### **ADDENDUM NO. 03**

Photographs, Drawings, Detail Sheets and Specification Sections issued with this Addendum:

- 1.5 EP2.1 Basement Floor - Power Plan:

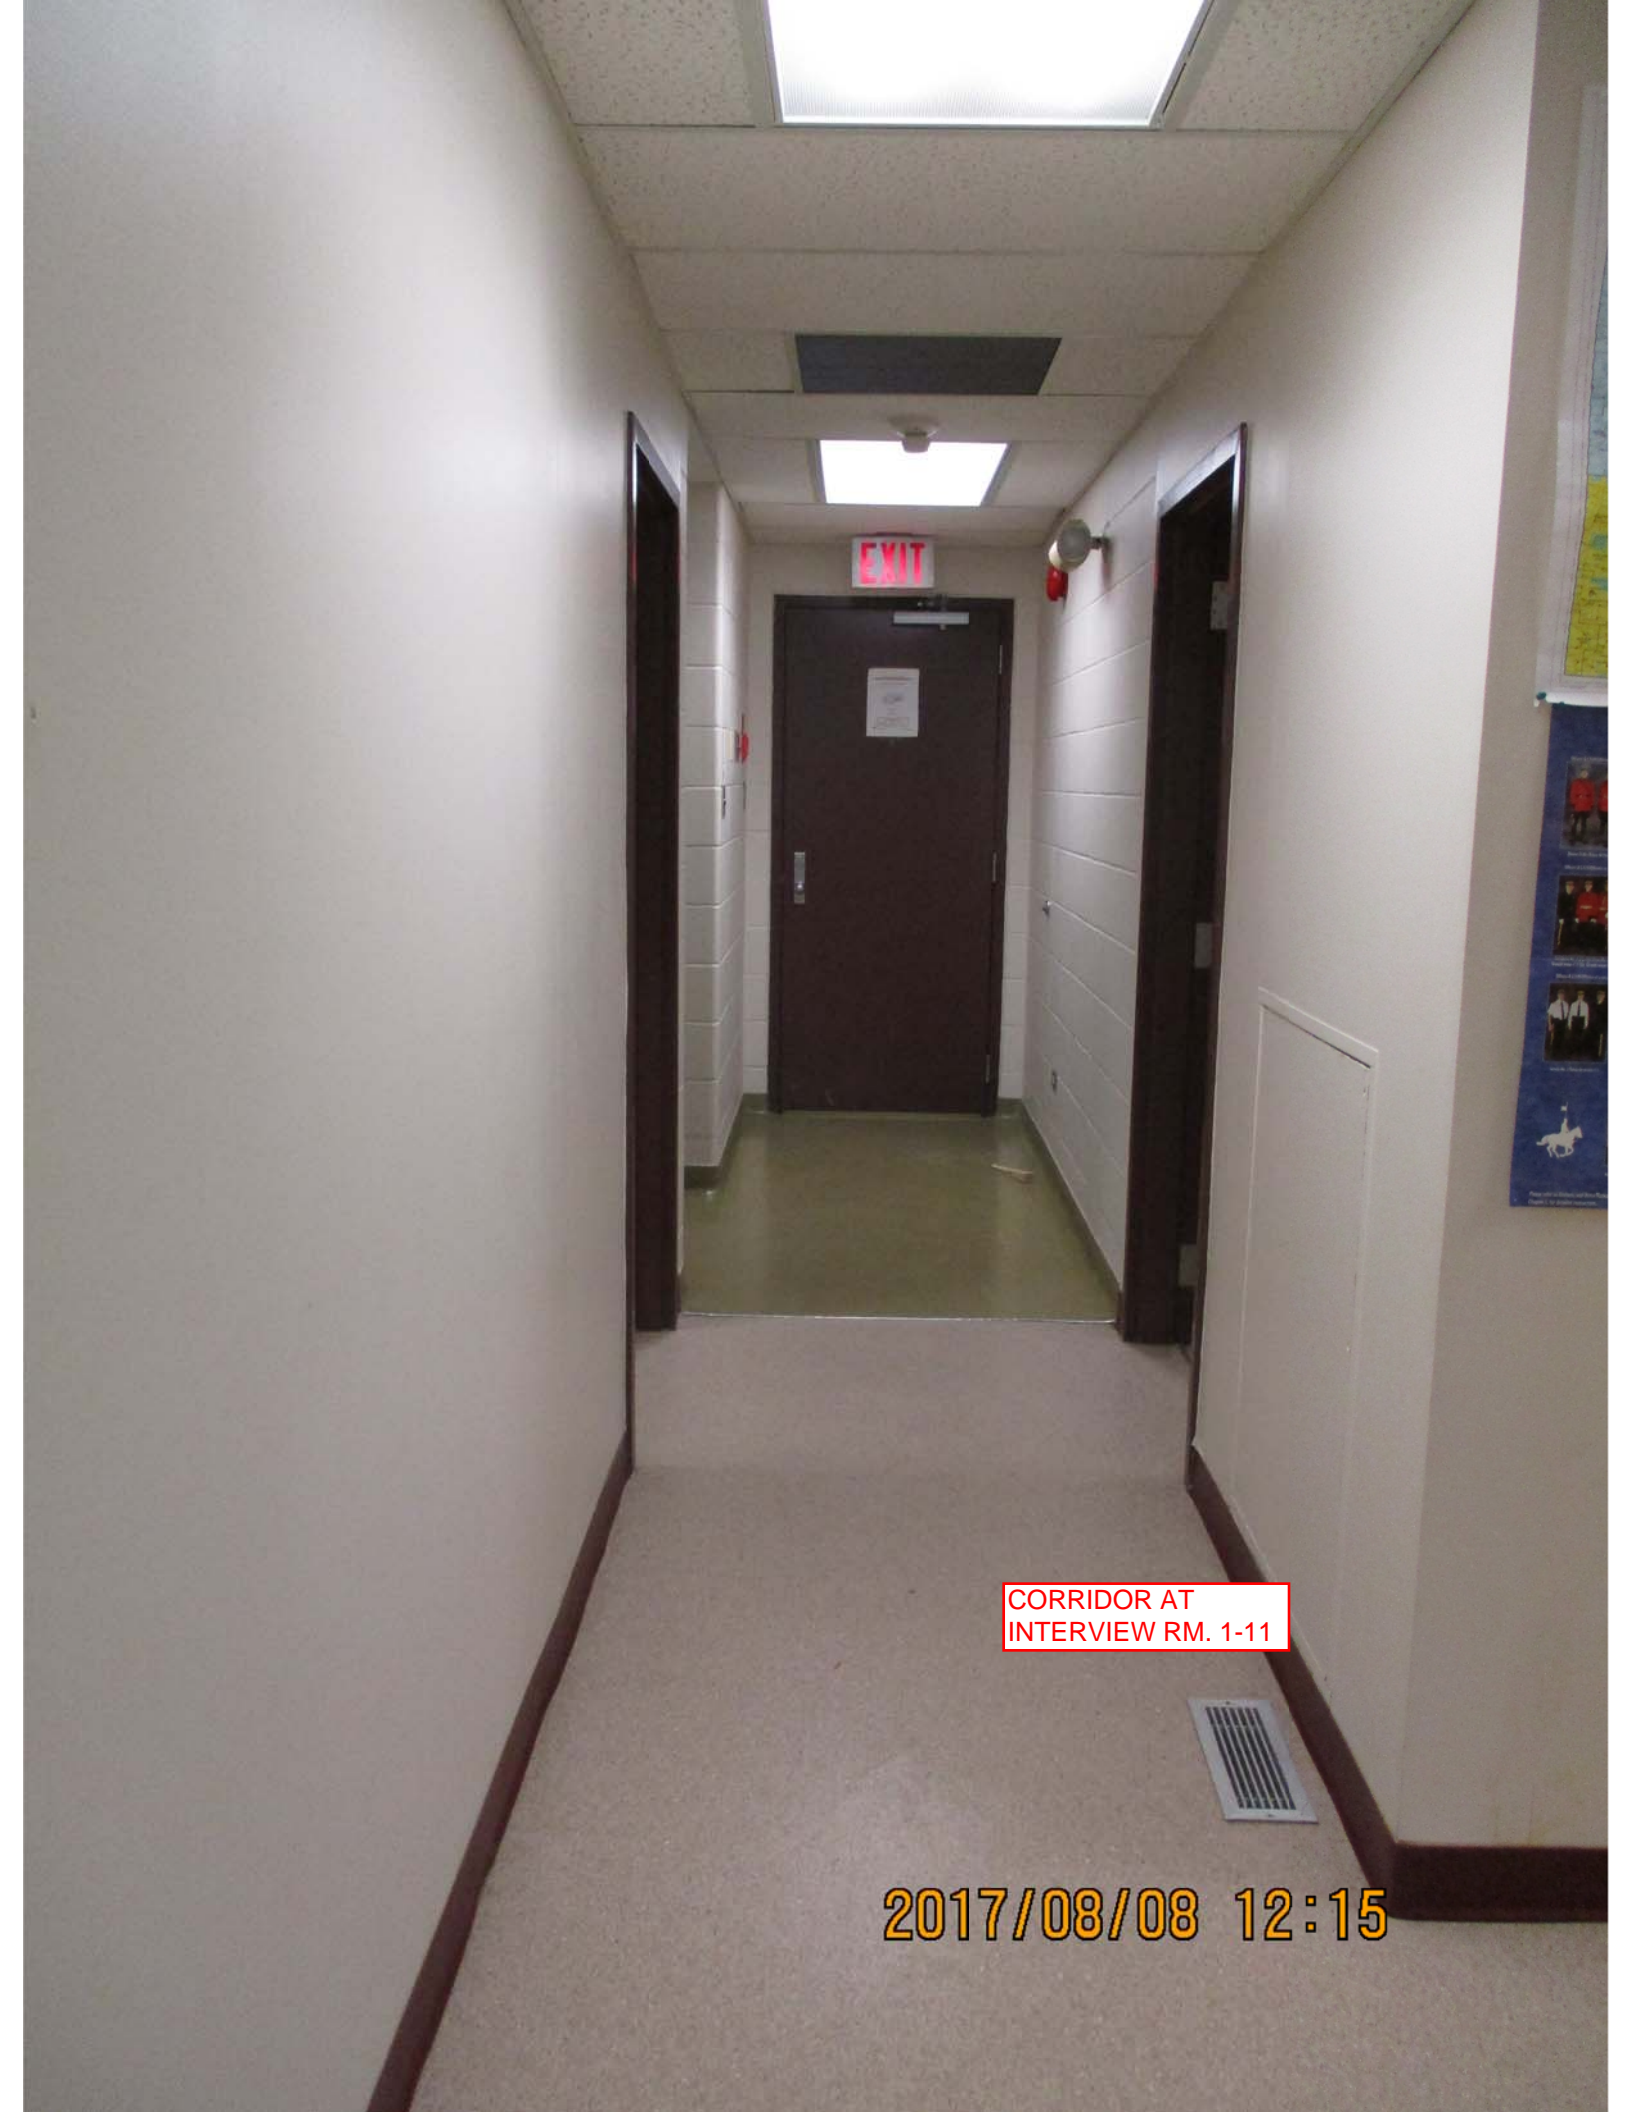
- a. Provide new secure telephone in new interview room. New phone shall be Guardian Telecom CIT-40 with Norstar Module ATA2. ATA2 module to be installed in telephone room. Provide rough in for phone outlet complete with 4" x 4" box and conduit to accessible ceiling space. Secure phone shall be wall mounted complete with securely fastened 350mm x 200mm x 19mm G1S prefinished plywood backing with PVC edges. Confirm mounting height and exact location with NCO on site. Mount and install phone as per manufacturer's instructions.

- b. Apply keynote below to blank keynote for door hold open devices:

WIRE AND CONNECT DOOR HOLD-OPEN DEVICE. WIRE AND CONNECT TO FIRE ALARM SYSTEM. PROVIDE NEW SMOKE DETECTORS WITHIN 1.5 M OF DOOR ON BOTH SIDES. HOLD-OPEN SHALL RELEASE ON FIRE ALARM. PROVIDE RE-VERIFICATION OF FIRE ALARM SYSTEM FOR ALL NEW AND RELOCATED DEVICES.
